Access Compliance Report

Public Rights-of-Way

(Curb Ramps)

Intersection ID: 2500	Main Street: CAMBRIDGE_BAY_DR	Cross Street: VISCOUNT_LN	Location:	S
ADA ID: 1C1C4EED7AEF	Ramp Type: PerpDiag	Initial Pass/Fail: Fail	Overall Compliance: No	Severity Score: 10
Codes/Mitigation Info/Possible Solution		Field Measurements/Component Compliance

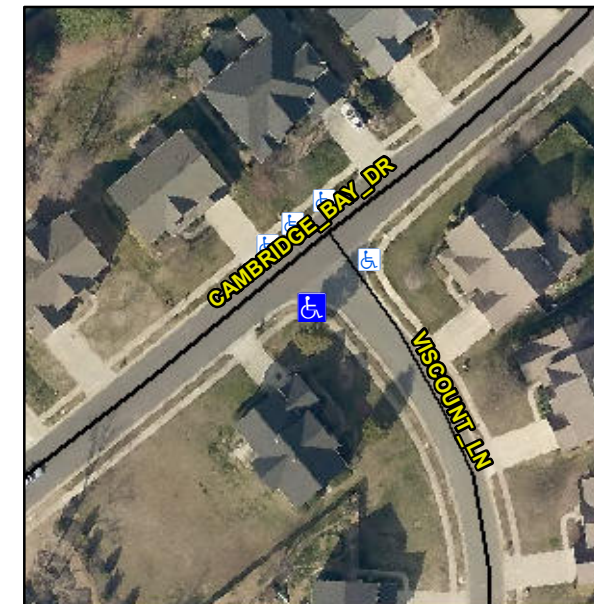
Not Found, R304.5.1, R304.5.3

Compliance	Description	Data	Compliance	Description	Data
N/A	Ramp Length (in)	48.0	Yes	Ramp Slope (%)	5.5
No	Ramp Width (in)	42.5	No	Ramp XSlope (%)	3.4
N/A	Flare Type LT	N/A	N/A	Flare Type RT	N/A
N/A	Flare Slope LT (%)	N/A	N/A	Flare Slope RT (%)	N/A
N/A	Flare Traversable LT?	N/A	N/A	Flare Traversable RT?	N/A
N/A	Landing Length (in)	N/A	N/A	DWS Provided?	N/A
N/A	Landing Width (in)	N/A	N/A	DWS Contrast?	N/A
N/A	Landing Slope (%)	N/A	N/A	DWS Length (in)	N/A
N/A	Landing X Slope (%)	N/A	N/A	DWS Full Width?	N/A
N/A	Landing Curb? (Y/N)	N/A	N/A	DWS Offset (in)	N/A
N/A	Shared Landing?	N/A			
N/A	Gutter Ponding?	N/A	N/A	Gutter Slope (%)	N/A
N/A	Gutter Lip Ht (in)	N/A	N/A	Gutter X Slope (%)	N/A
N/A	Painted X Walk1?	No	N/A	Painted X Walk2?	No
	X Walk 1 Direction	To NE		X Walk 2 Direction	To NW
N/A	X Walk 1 Width (in)	N/A	N/A	X Walk 2 Width (in)	N/A
	X Walk 1 Slope (%)	1.4		X Walk 2 Slope (%)	4.5
	X Walk 1 X Slope (%)	4.2		X Walk 2 X Slope (%)	0.3

N/A	Ramp inside XWalk1?	N/A	N/A	Ramp inside XWalk2?	N/A
	Road Slope (%)	4.5	N/A	Clear Space?	N/A
	Road X Slope (%)	5.5	N/A	Clear Space to XWalk (in)	N/A
N/A	Any Obstructions?	N/A	N/A	Storm Grate/Utility Hazard?	N/A
	Obstruction Type			Storm Grate/Utility Type	
		N/A			N/A
		Yes		Surface Condition? (G/P)	Good

Remove & Replace Curb Ramp With Two New Directional Ramps or Equivalent.
